**CLARIFICATION No: 1**

**to the TENDER DOSSIER**

**Publication Ref: SIHHAT/2018/SUP/INT/10**

**Subject: Supply of Medical Equipment for the Secondary Healthcare Premises**

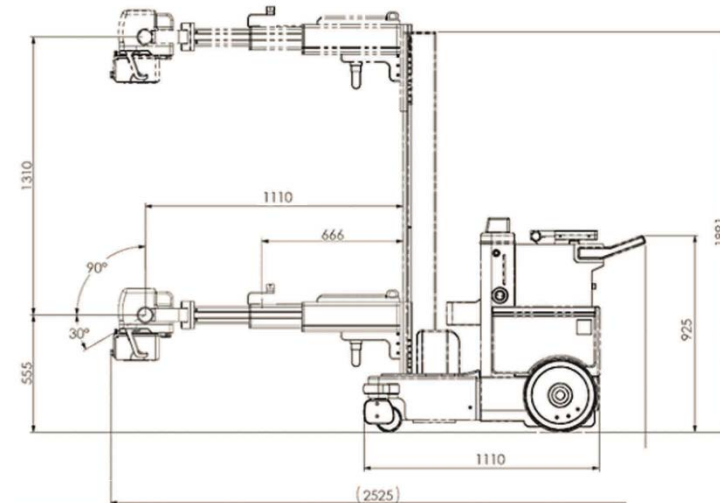
<p><b>Question 408:</b></p>	<p>Item <b>14.5.5:</b> May the item revised as; <i>“The horizontal and vertical mobility of the tube carrier arm shall allow it to be adjusted without moving the device. For this purpose, the height of the focal point of the X-ray tube shall be adjustable from at least 55 cm to 200 cm at the desired height and the horizontal movement of the arm shall be extended at least up to 120 cm.”</i></p> <p>The height of the focal point of the X-ray tube is adjustable from 53cm - 202 cm in the system. To comply with the technical specification and participate in the tender, it is kindly requested that the technical specification be amended as specified.</p>
<p><b>Answer 408:</b></p>	<p>Please see Changes to Tender Dossier</p>
<p><b>Question 409:</b></p>	<p>Item <b>14.5.5:</b> May the item revised as; <i>“The horizontal and vertical mobility of the tube carrier arm shall allow it to be adjusted without moving the device. For this purpose, the height of the focal point of the X-ray tube shall be adjustable from at least 78,5 cm to 204.5 cm at the desired height and the horizontal movement of the arm shall be extended at least up to 107 cm.”</i></p>

<p><b>Answer 409:</b></p>	<p>Please see Changes to Tender Dossier</p>
<p><b>Question 410:</b></p>	<p>Item <b>14.5.5:</b> May the item revised as; <i>“The horizontal and vertical mobility of the tube carrier arm shall allow it to be adjusted without moving the device. For this purpose, the height of the focal point of the X-ray tube shall be adjustable from at least 55 cm to 200 cm at the desired height and the horizontal movement of the arm shall be extended at least up to 120 cm. <b>The system shall be able to move within 4 seconds after it is turned on and be ready to operation within 25 seconds.</b>”</i></p>
<p><b>Answer 410:</b></p>	<p>Please see Changes to Tender Dossier</p>
<p><b>Question 411:</b></p>	<p>Item <b>14.5.5:</b> May the item revised as; <i>The horizontal and vertical mobility of the tube carrier arm shall allow it to be adjusted without moving the device. For this purpose, the height of the focal point of the X-ray tube shall be adjustable from at least 70 cm to 197 cm at the desired height and the horizontal movement of the arm shall be extended at least up to 107 cm.”</i></p>

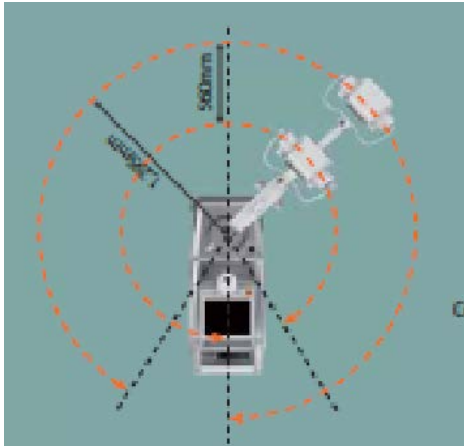
For safe driving and effective use of these types of mobile DR systems, the height of the tube stand is limited to a maximum of 180 cm.

- 3. In order for the arm of the device to extend up to 120 cm from the horizontal axis, the length of the tube carrier arm of the device must be at least 80, which is not possible and disrupts the general equilibrium of the device. This value is produced as a maximum of 100 cm for standard x-ray mobile devices.

Changing this article very important for the compete on equal terms with importer companies. And it's also very important in terms of our country.

<b>Answer 412:</b>	Please see Changes to Tender Dossier
<b>Question 413:</b>	<p>Item <b>14.5.5:</b> May the item revised as; <i>“The horizontal and vertical mobility of the tube carrier arm shall allow it to be adjusted without moving the device. For this purpose, the height of the focal point of the X-ray tube shall be adjustable from at least <b>62 cm to 200 cm</b> at the desired height and the horizontal movement of the arm shall be extended at least up to <b>110 cm.</b>”</i></p> <p>Above changes will not affect usability of the products since the mentioned lengths are much more than enough. Above requests at the former text are specific to some products and will strictly limit the competition.</p>
<b>Answer 413:</b>	Please see Changes to Tender Dossier
<b>Question 414:</b>	Item <b>14.5.5:</b> May the item revised as; <i>“The horizontal and vertical mobility of the tube carrier arm shall allow it to be adjusted without moving the device. For this purpose, the height of the focal point of the X-ray tube shall be adjustable from at</i>
